SITE PLAN REVIEW COMMITTEE MEETING AGENDA

A. Review and take action: Edge Field Preliminary Plat

B. Review and take action: Hunter Oaks Enclave Preliminary Plat

RE: Edge Field Preliminary CSM Review

PART OF THE NORTHEAST 1/4 OF THE SOUTHEAST 1/4 OF SECTION 7, T.8N., R.15E., CITY OF WATERTOWN, JEFFERSON COUNTY, WISCONSIN.

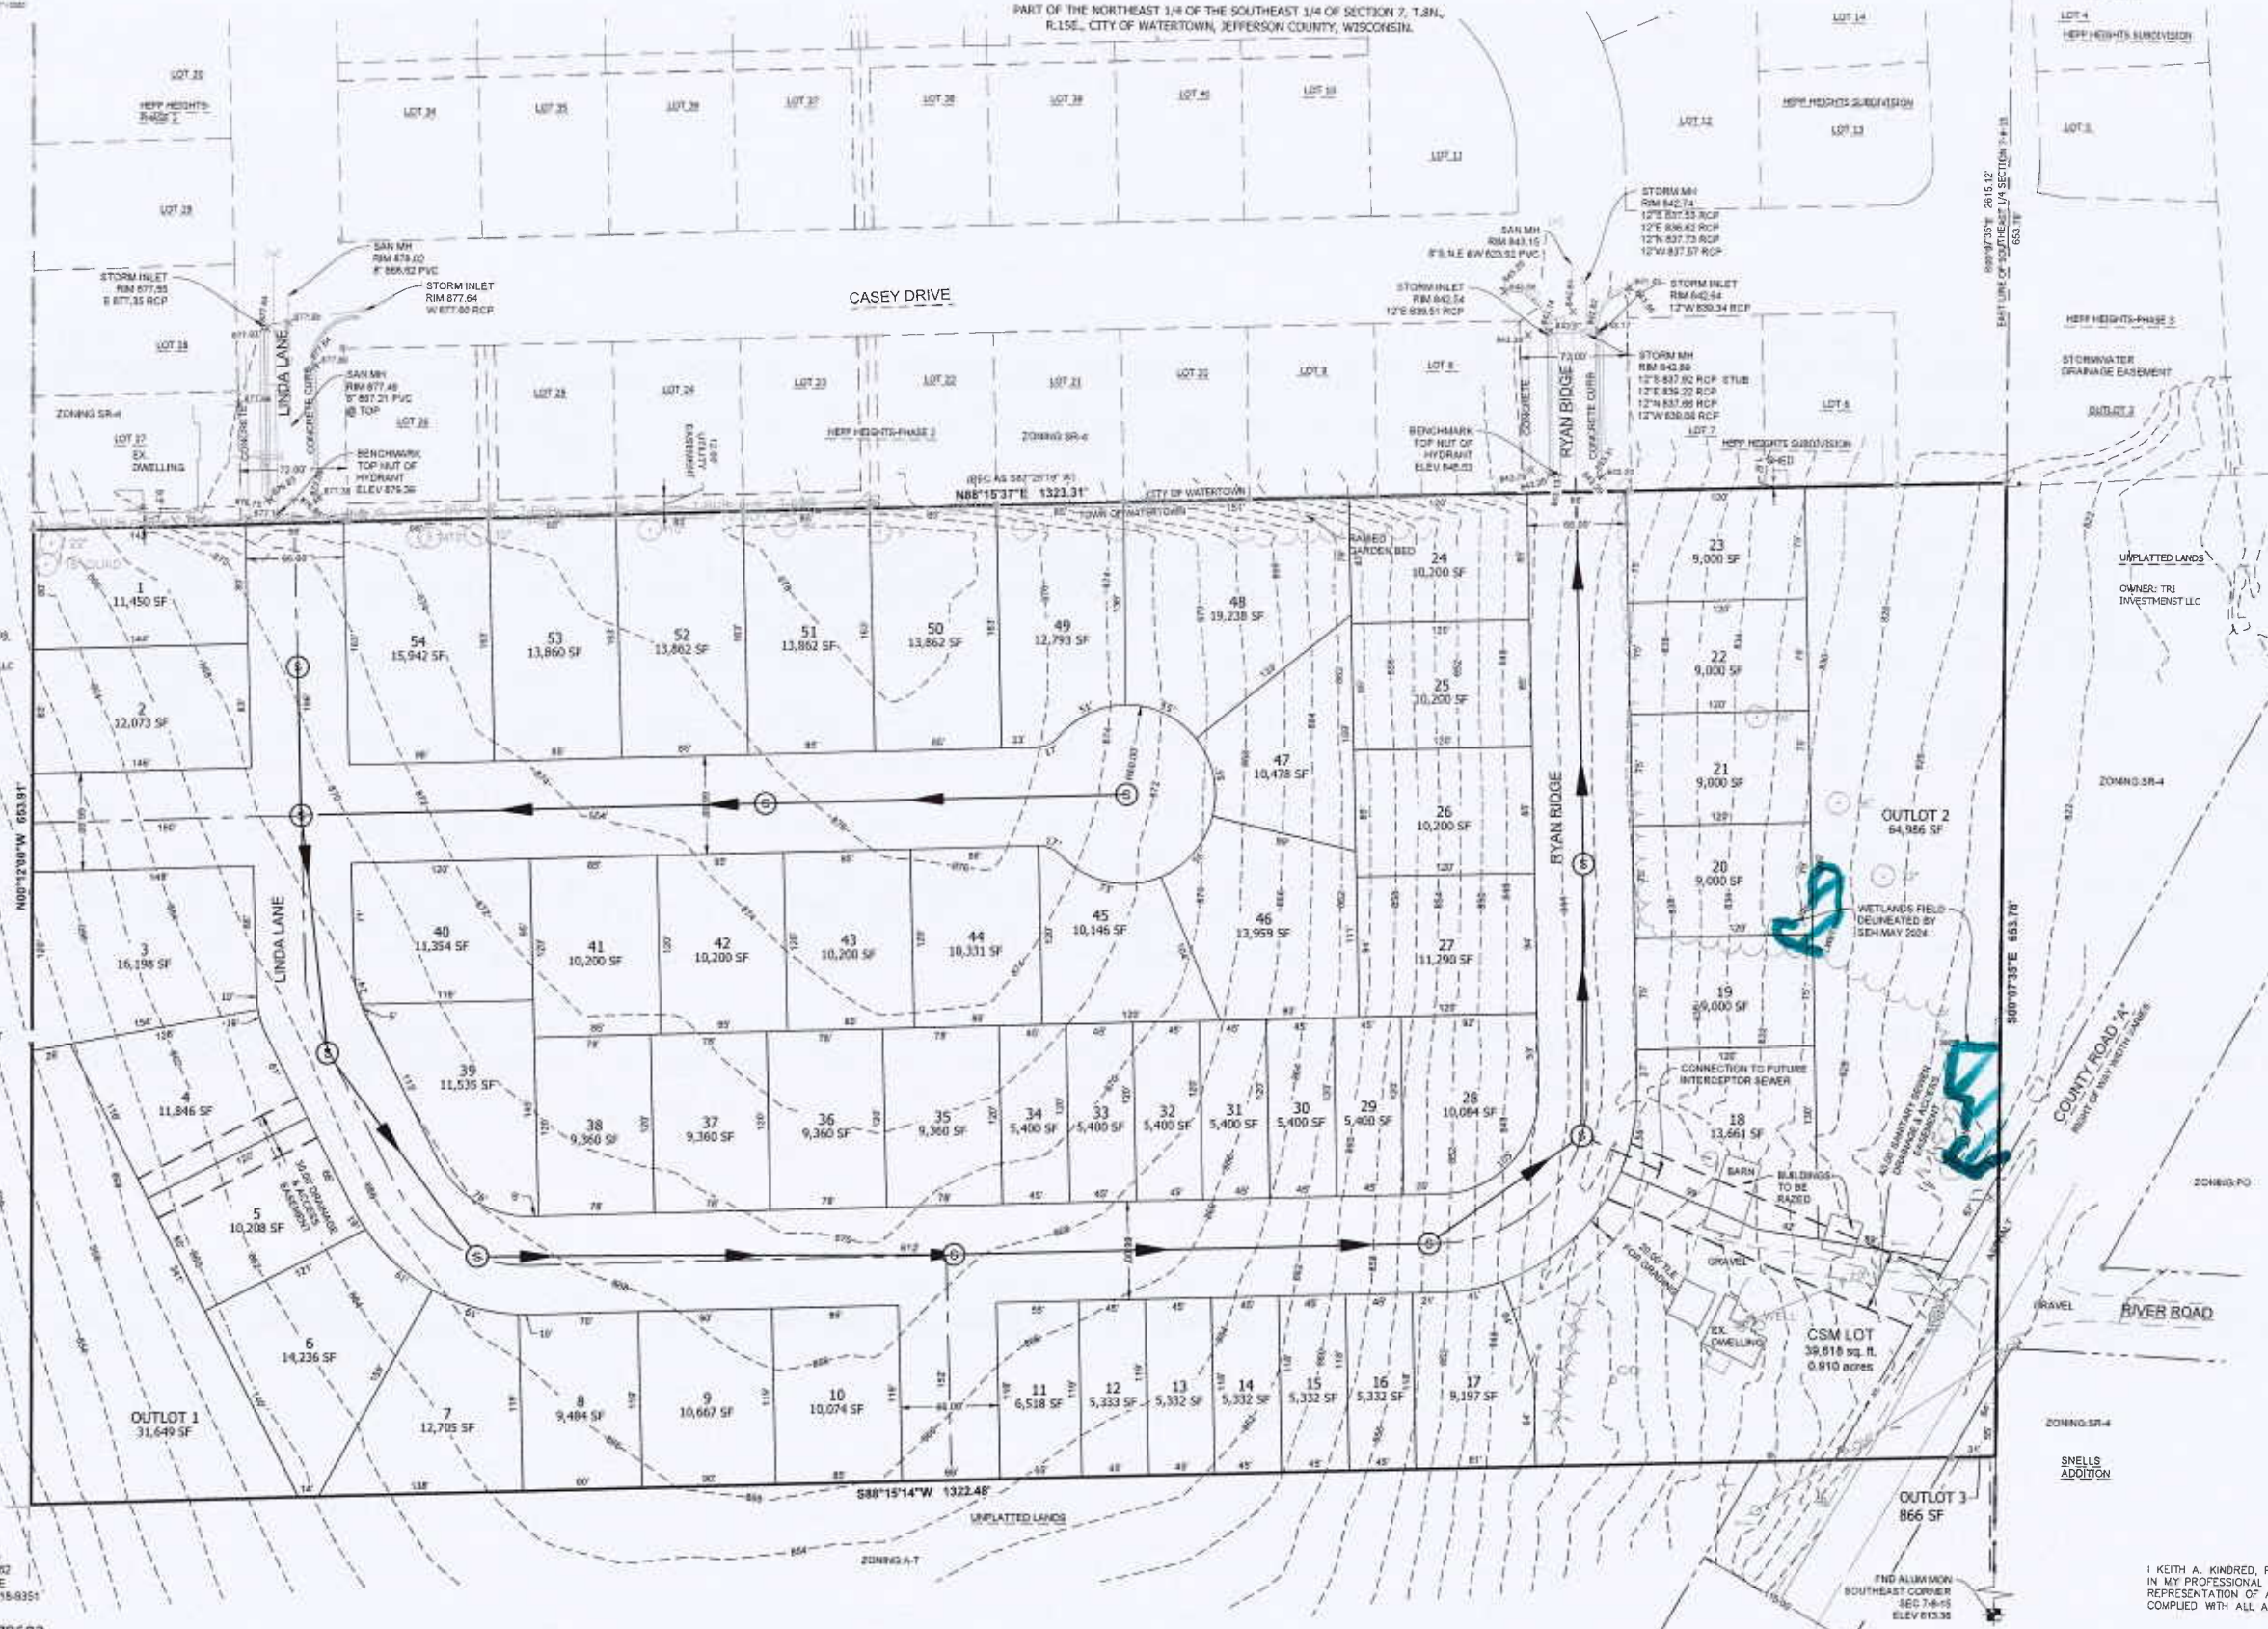
The County Surveyor and I have reviewed the preliminary CSM for Edge Field, prepared by Keith Kindred, PLS, job no. 178692, as dated October 15, 2024, and have the following comments:

- label the radii of the curves
- label the City/Town corporate limits
- Include a road name for the east/west cul-du-sac road and the southernmost road stub

For the final plat, any stormwater outlots (outlot 1 and 2) a note will need to be placed on the plat stating that all lots have an undivided interest in the outlots. Draft language can be provided if needed.

PRELIMINARY PLAT OF HUNTER OAKS ENCLAVE

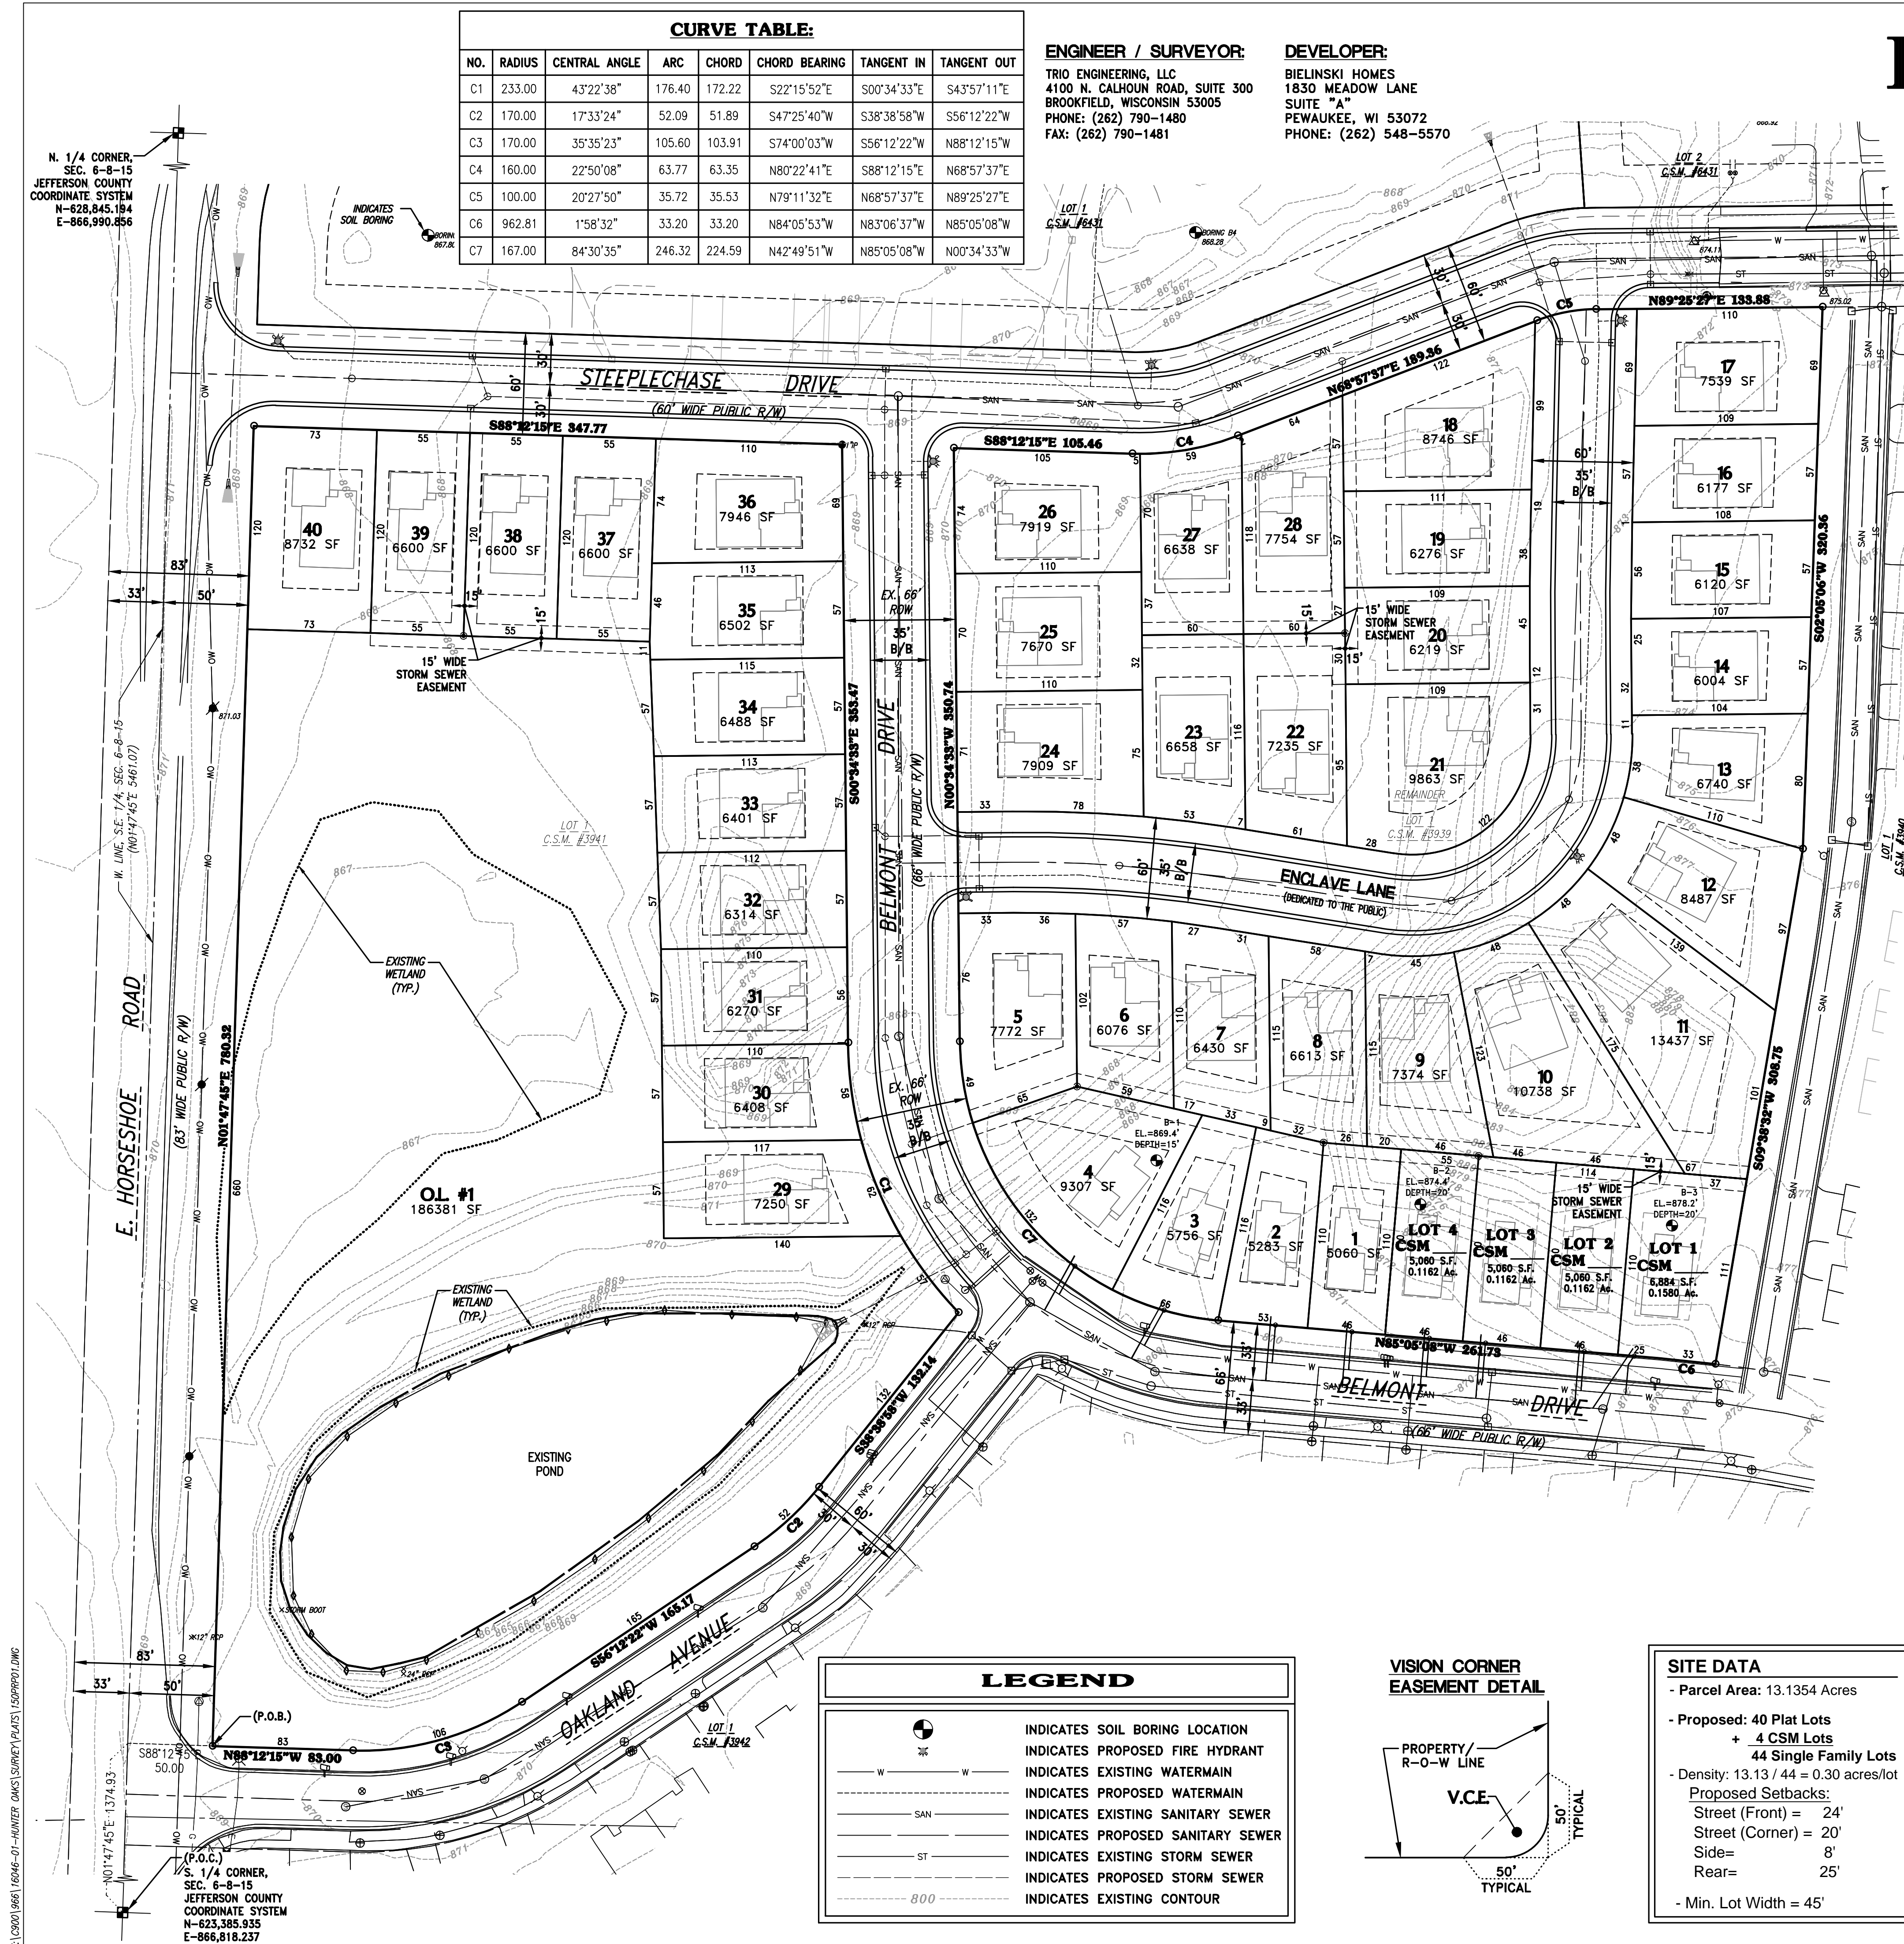
- The subdivision is tied to the north and south ends of the quarter line of Section 6, Town 8 North, Range 15 East, beginning at the south quarter corner. The center quarter corner has a tie sheet from 2018. Was this corner searched for, and not recovered?
